**JUDGE DOYLE SQUARE - BLOCK 88
DESIGN ALTERATIONS - PEDESTRIAN PARKING GARAGE ENTRY**

City of Madison
Public Parking & Podium - Phase 1 SIP

OCTOBER 03, 2018

The following pages are a response to the comments provided by the Urban Design Commission on September 26, 2018. Pages 4-16-A.1 through 4-16-A.7 exhibit two options that we feel acknowledge the concerns expressed by the committee members. All previously submitted sheets that contain the pedestrian garage entry on Doty Street and Wilson Street, would be superseded by the option that is deemed acceptable by the UDC.

ORIGINAL

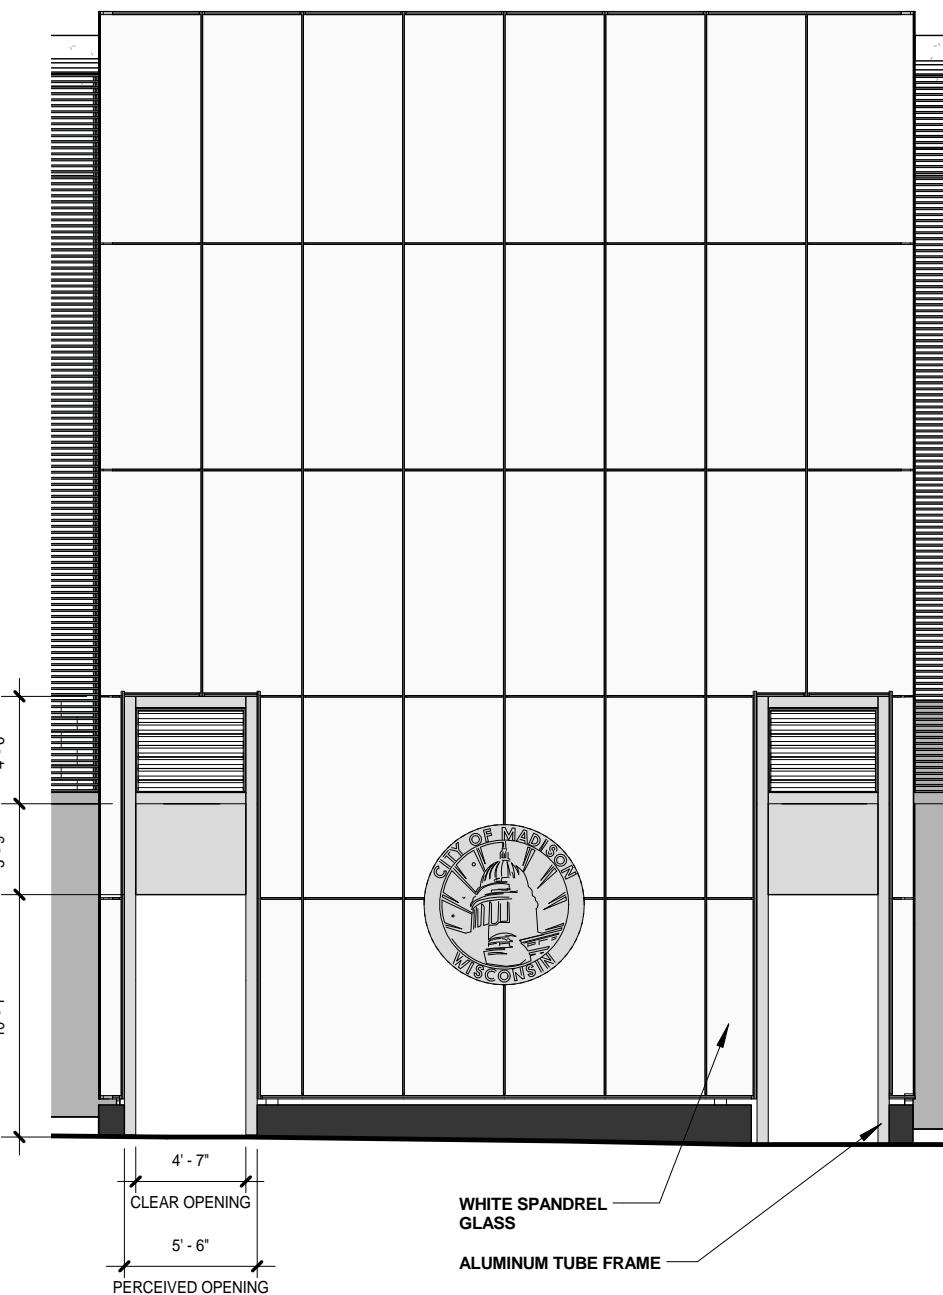
DESCRIPTION: This option was previously presented at the UDC meeting on 09/26/2018. The commission was concerned about the proportion of the pedestrian openings versus the overall scale of the vertical white spandrel glass. This elevation is shown as a comparison for options A and B which have been created as a response to the UDC comments

OPTION A

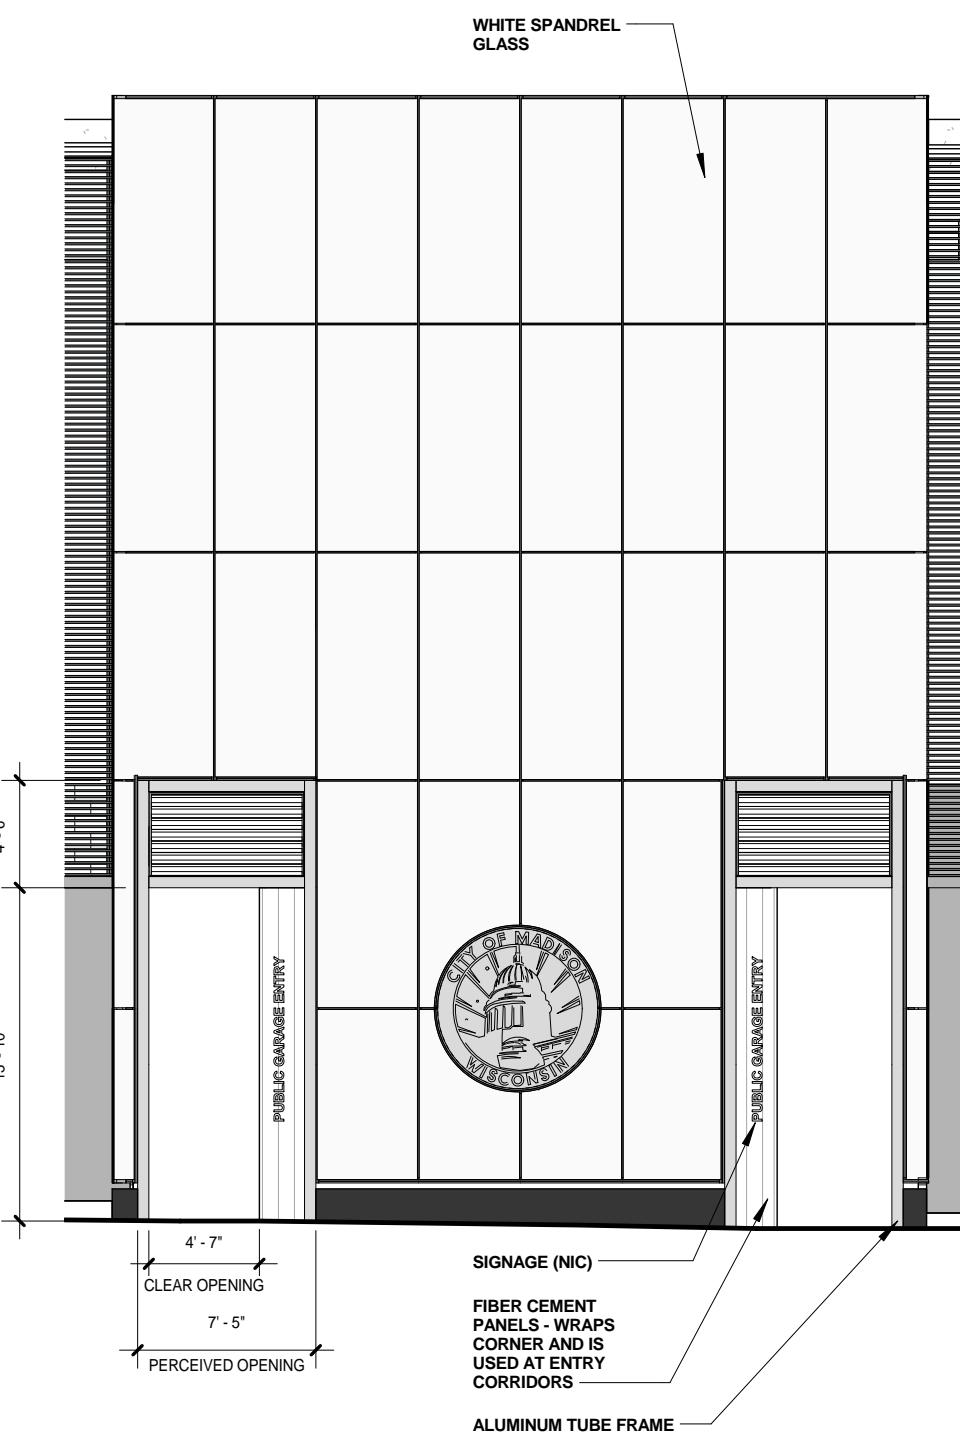
DESCRIPTION: The pedestrian entries, which originally had a clear opening of 3'-8", have been widened to 4'-7" with the total width of the perceived opening (including the aluminum frame) to be 5'-6".

OPTION B

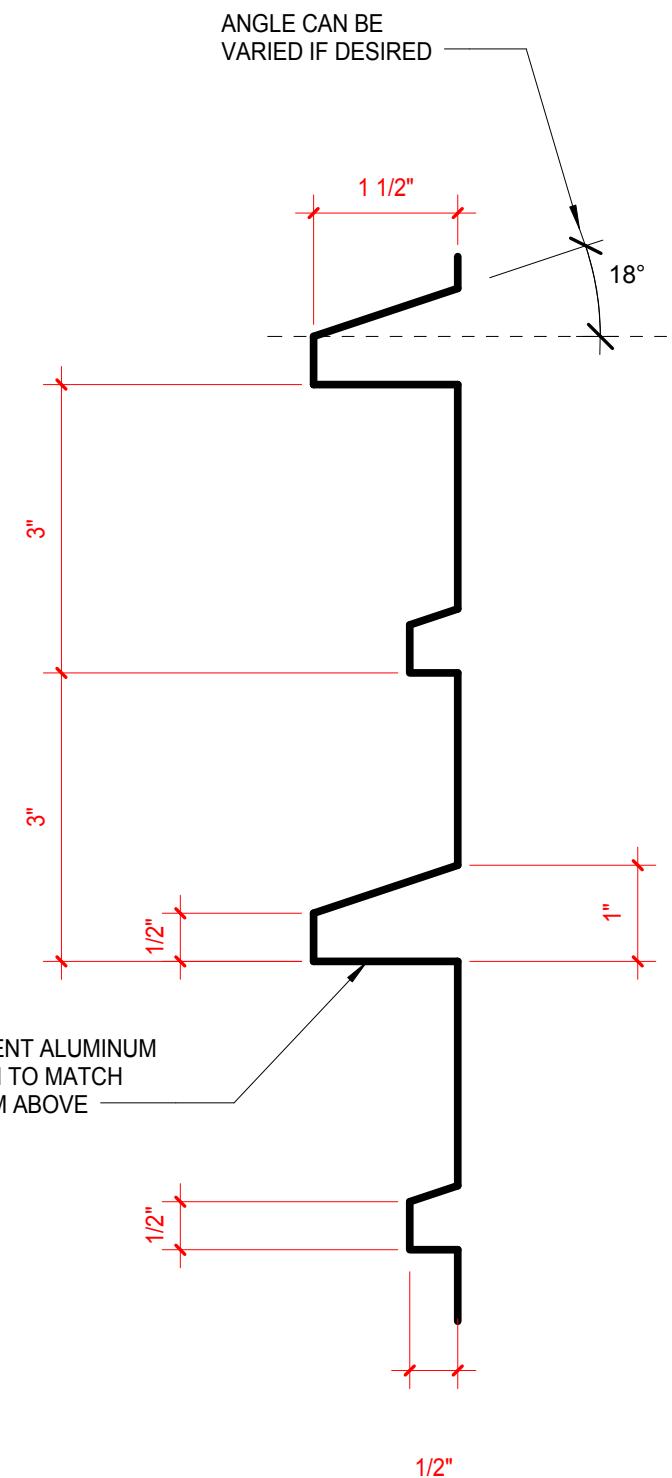
DESCRIPTION: The clear openings at the entries have been widened to 4'-7" and the total width of the perceived opening has been increased to 7'-5". The fiber cement wall panels, which were previously only on the inside of the garage, now wrap the corners of the elevator shaft wall and have a small presence on the exterior façade. These panels are inset 8" from the exterior face of the aluminum frame and have the potential to support signage options, as shown with the vertical lettering in the sketch.
